PARTS FLASH

REFERENCE NO.: RF-26-04

APPLICABLE MODEL(S): 2024-2026 CX-90 and 2025-2026 CX-70

SUBJECT: ORDERING REQUIREMENT FOR AT COMPONENTS FOR H3T (INLINE 6)

1. Water hose discontinuation

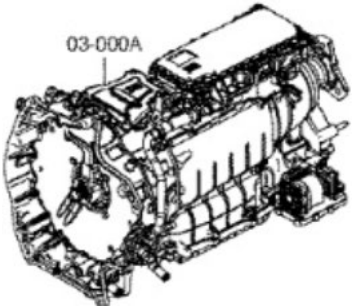
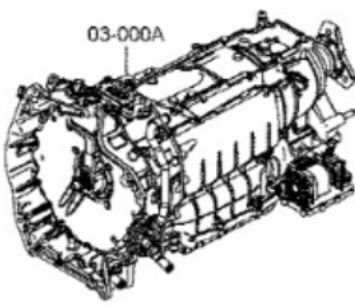
Early production vehicles were equipped with a water hose that was later discontinued. When replacing the AT component on vehicles that require water hose removal, remove the water hose. Current service AT components do not include a provision for water hose installation, and the hose does not need to be reinstalled.

Prior to water hose discontinuation (water hose shown in purple)	After water hose discontinuation (harness bracket shown in purple)

2. Inverter is not included with the service AT component

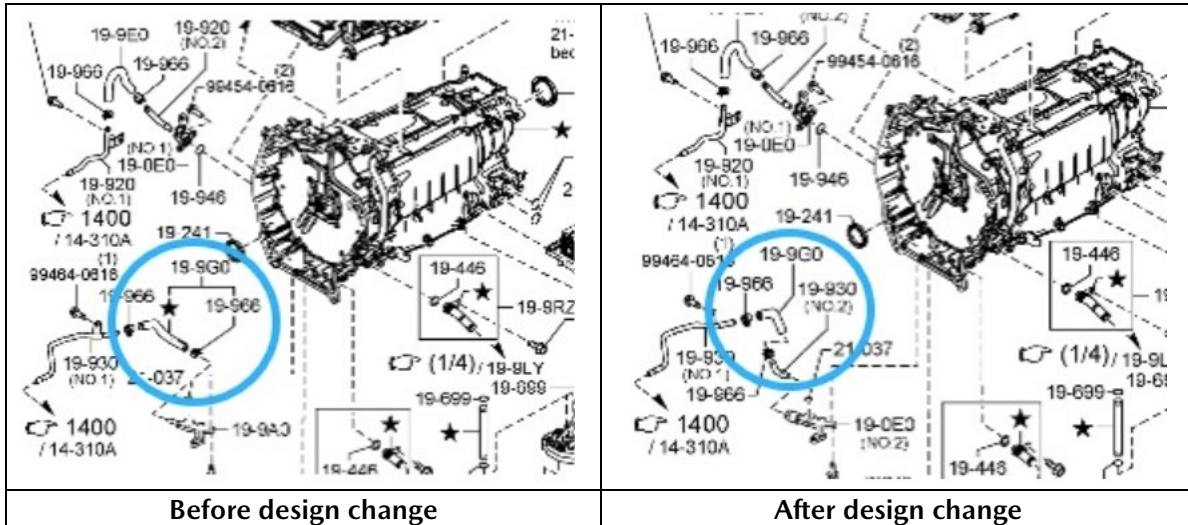
The inverter is reused and is not included with service AT components. Before ordering, check the AT component part number in GEPC and use Table A or Table B to order all required parts together.

AT component with inverter	Service AT component without inverter

IMPORTANT: If DTCs for inverter are present or WSM indicates inverter replacement is needed, order inverter separately.
